**Re: Powell Creek Solar, LLC,
OPSB Case No. 20-1084-EL-BGN**

Included with this letter are a table summarizing the changes from the Certificated Layout to the Updated Layout and figures depicting these changes.

Table 1. Layout Comparison Summary

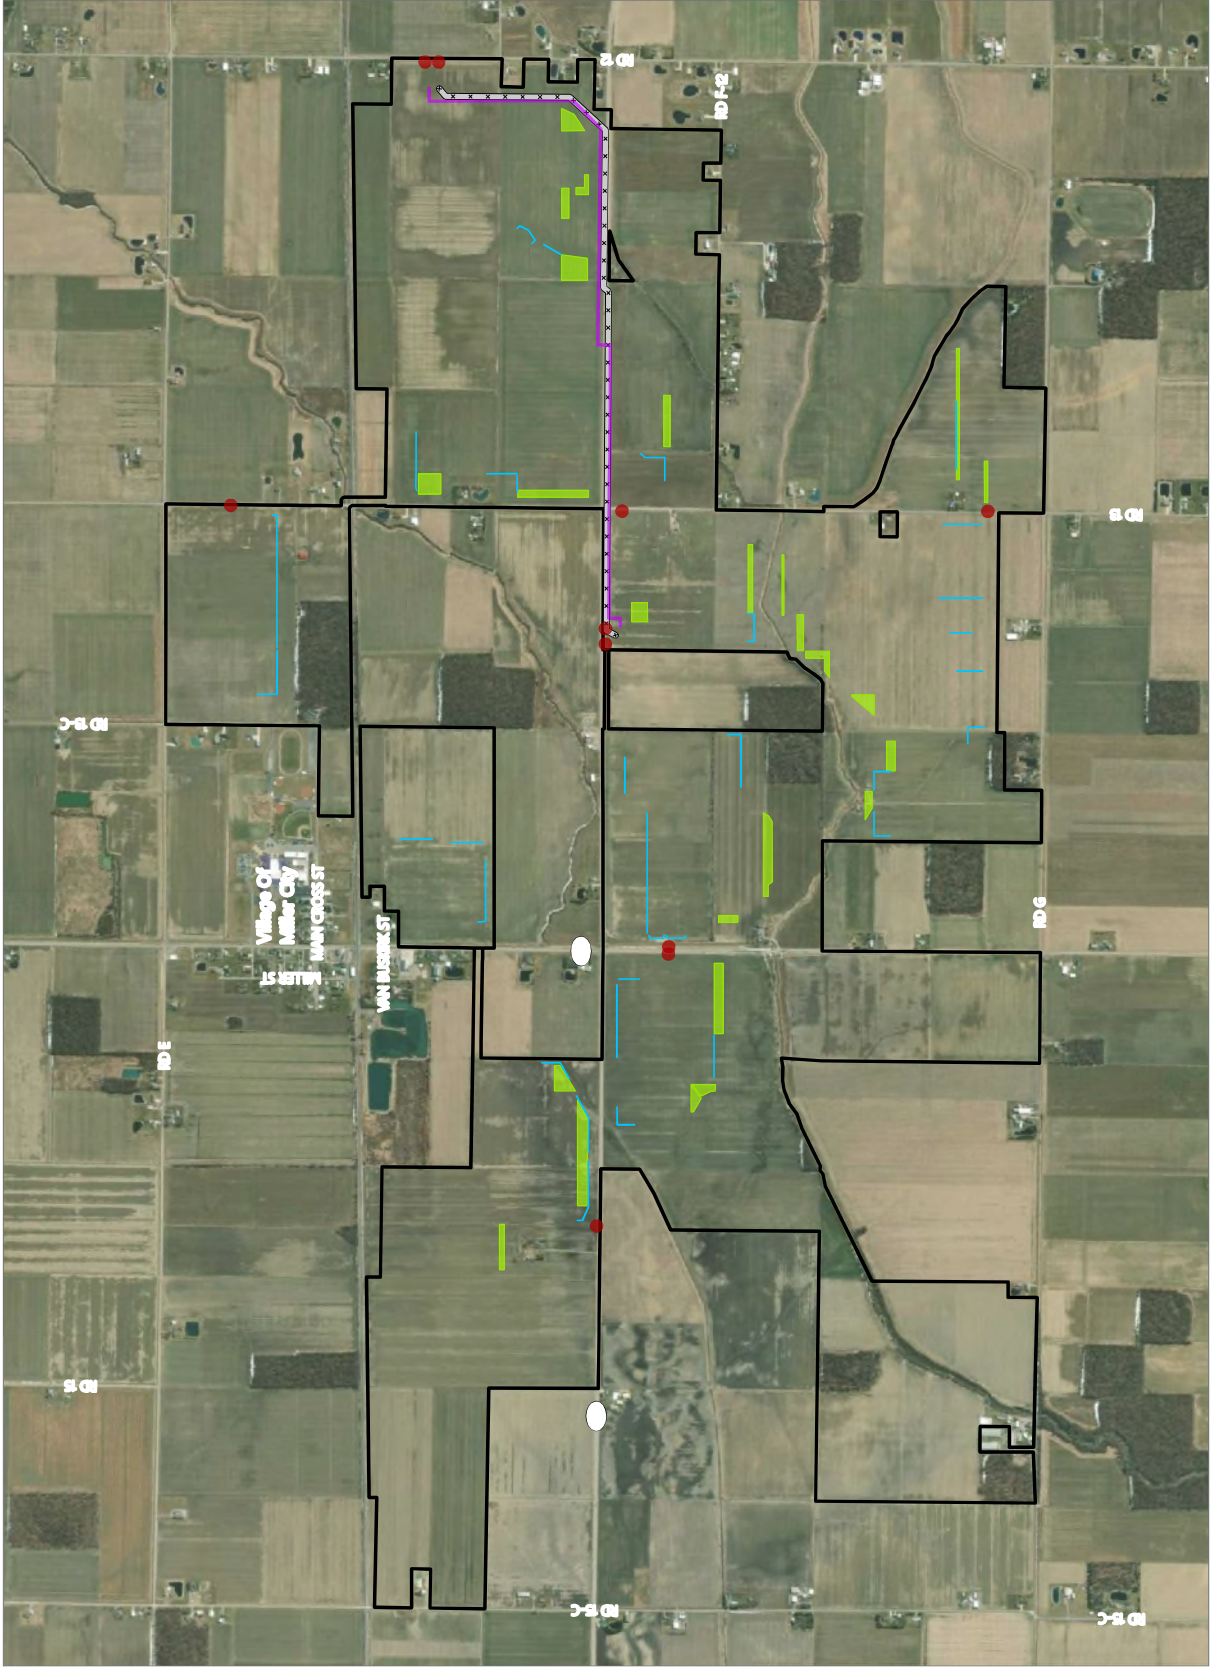
PV Panel Area	PV panel area has decreased by approximately 20%. PV panel areas are depicted on Figure 3.	This change represents a reduction in impacts. All PV panels are location within the fenceline area presented in the Certificated Layout.
Facility Fenceline	The footprint of the Facility fenceline has decreased by approximately 15%. Figure 6 depicts this change.	This change represents a reduction in impacts. The fenceline of the Updated Layout is entirely within the fenceline area presented in the Certificated Layout.

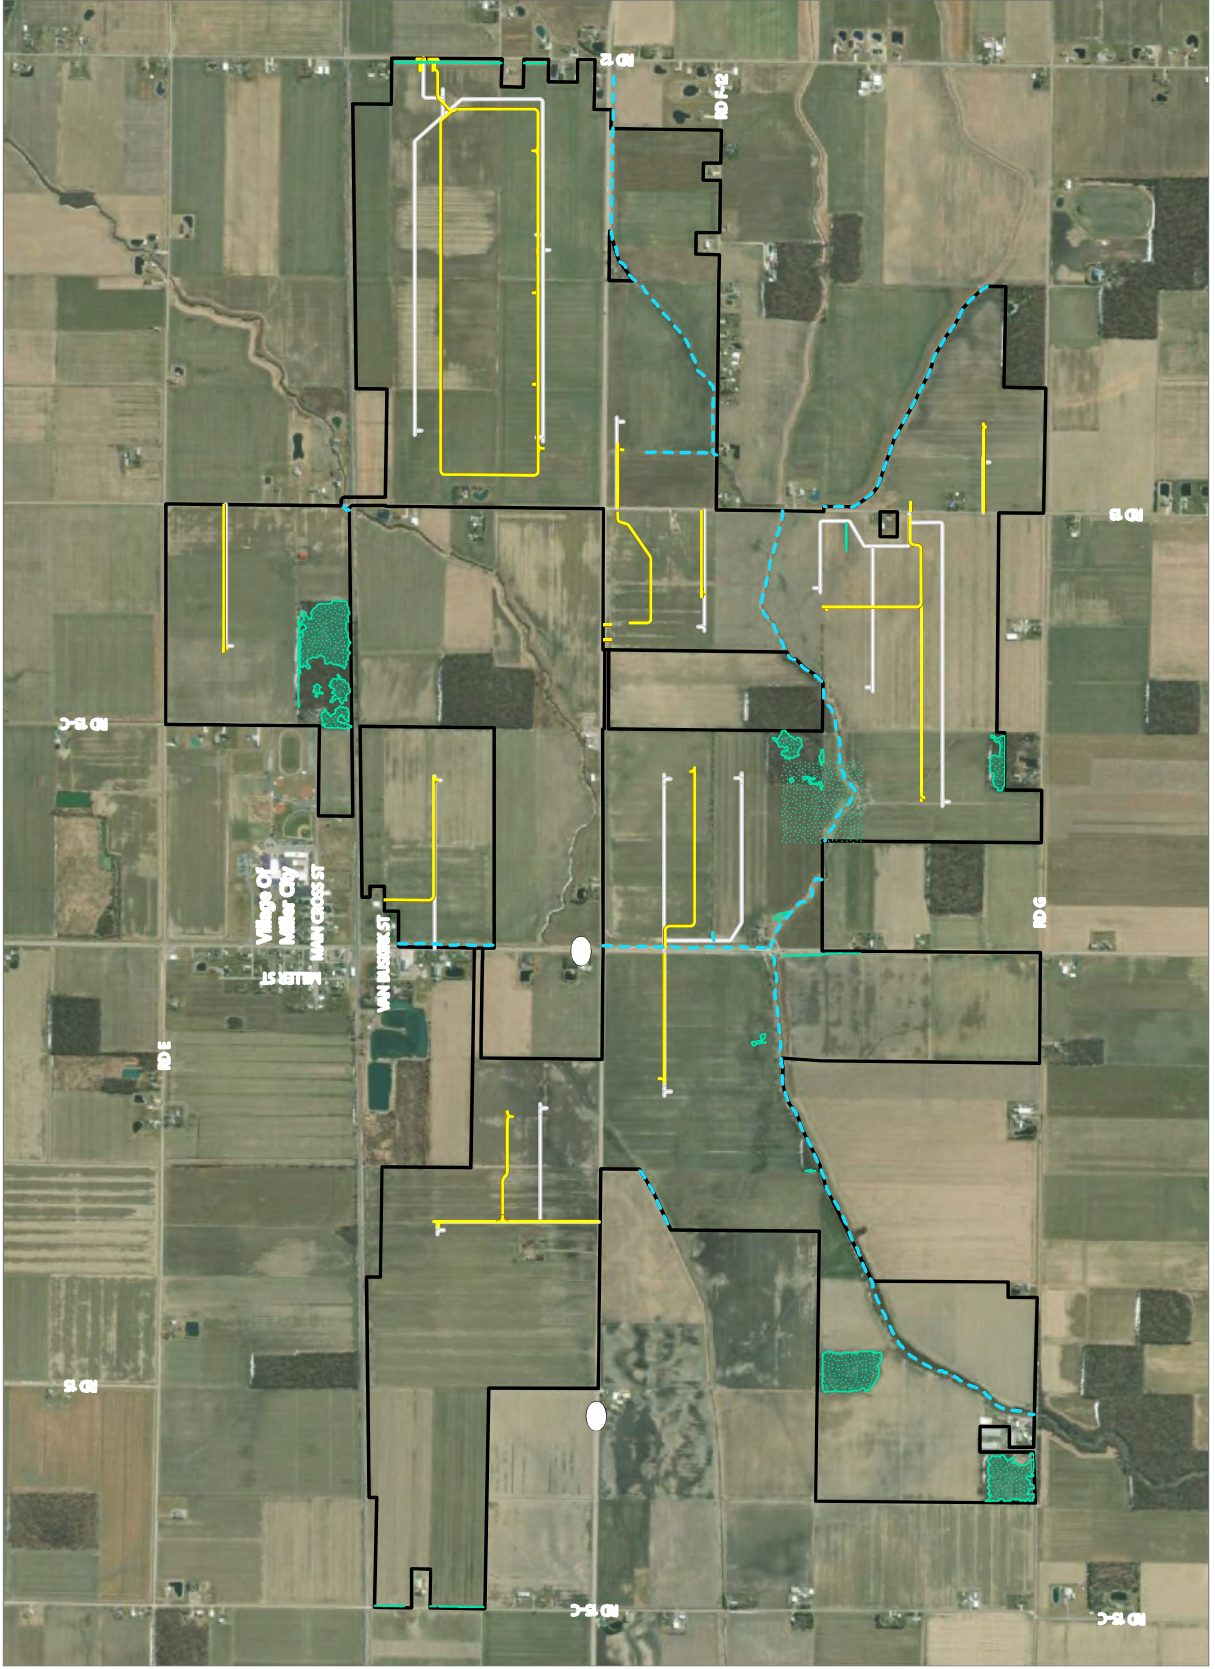
Access Roads	The total length of access roads has been reduced by approximately 5%. See Figure 4 for a depiction of this change.	This change represents a reduction in impacts.
	The access point nearest to Miller City has been shifted from SR 108 to Van Buskirk Street.	This change moves an access point off of a state highway and moves the access point further from non-participating residences. Furthermore, all residences on Van Buskirk Street are participants, and as such this represents a reduction in impacts.
